STATEMENT OF ENVIRONMENTAL EFFECTS:

This application requests Council consent for a number of minor design amendments proposed for the residential dwelling located at 21 Wanniti Rd in Belrose. This design was originally approved by Council on 30.01.2013 (DA2012/0936), with a subsequent design modification approved on 27.12.2013 (MOD2013/0163).

PROJECT
PROPOSED NEW RESIDENCE
21 WANNITI ROAD
BELROSE

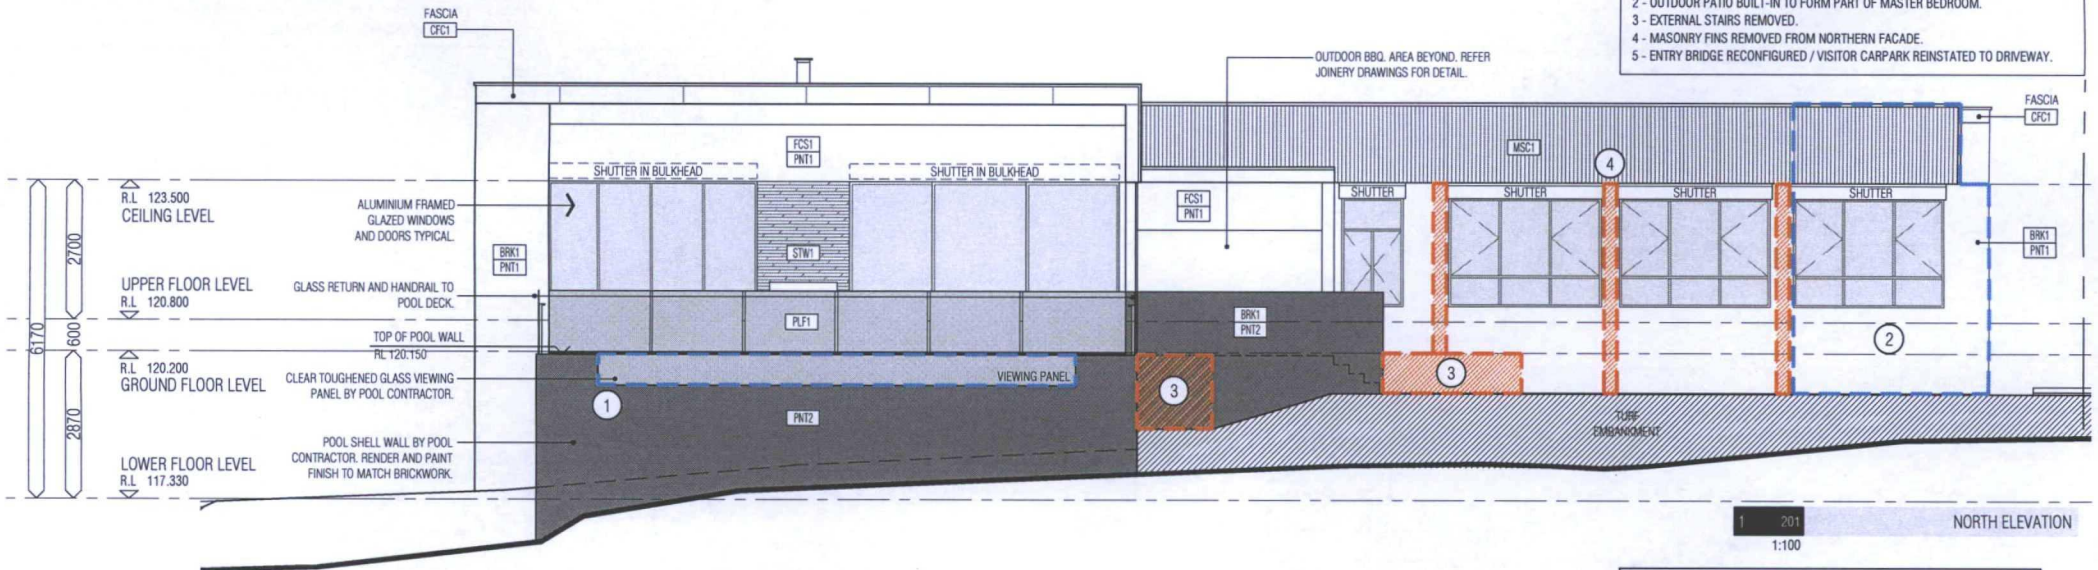
- 1 - VIEWING WINDOW ADDED TO SWIMMING POOL.
- 2 - OUTDOOR PATIO BUILT-IN TO FORM PART OF MASTER BEDROOM.
- 3 - EXTERNAL STAIRS REMOVED.
- 4 - MASONRY FINIS REMOVED FROM NORTHERN FACADE.
- 5 - ENTRY BRIDGE RECONFIGURED / VISITOR CARPARK REINSTATED TO DRIVEWAY.

DRAWING NAME
BUILDING ELEVATIONS
SHEET 1

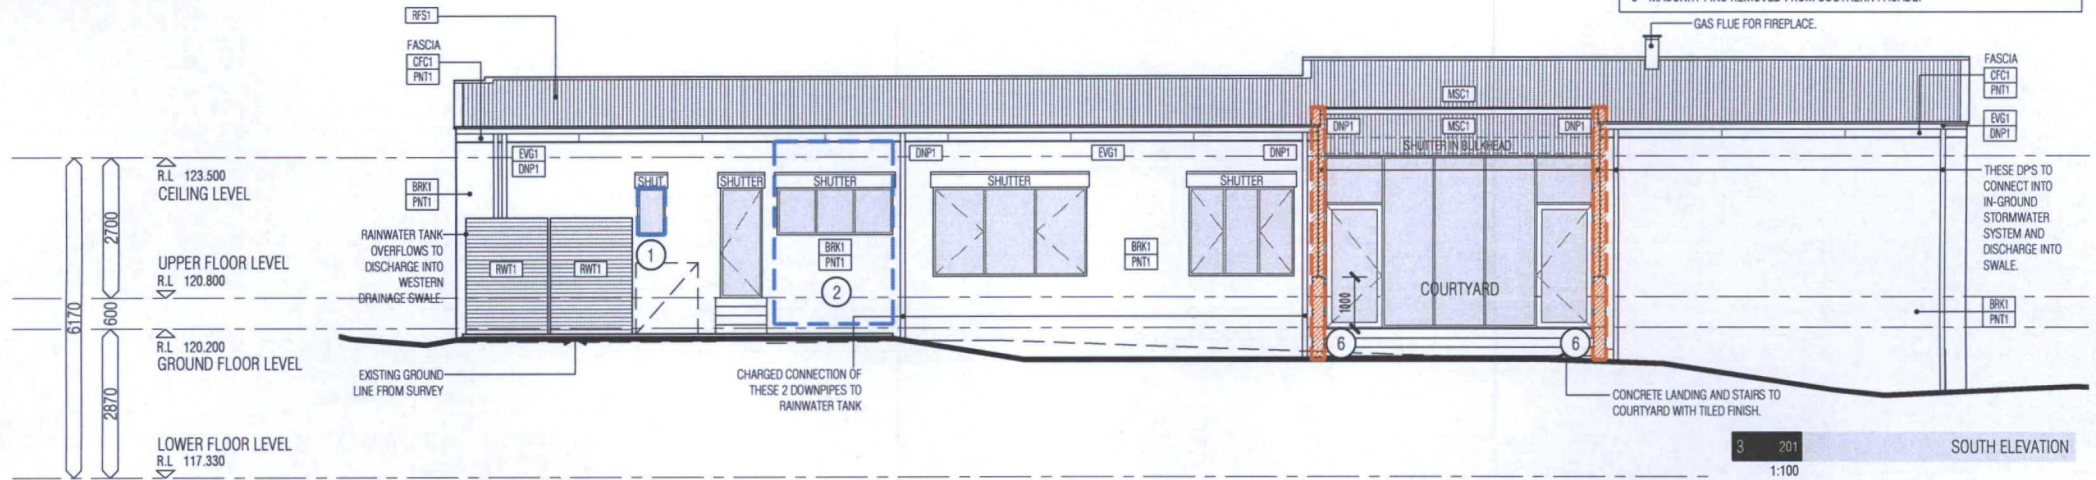
- 1 - EXTERNAL WINDOW ADDED TO MASTER ENSUITE BATHROOM (OBSCURE GLASS).
- 2 - DRYING COURT BUILT-IN TO FORM PART OF MAIN BATHROOM.
- 3 - OUTDOOR PATIO BUILT-IN TO FORM PART OF MASTER BEDROOM.
- 4 - EXTERNAL WINDOW RECONFIGURED.
- 5 - MASONRY FINS REMOVED FROM WESTERN FACADE.
- 6 - MASONRY FINS REMOVED FROM SOUTHERN FACADE.
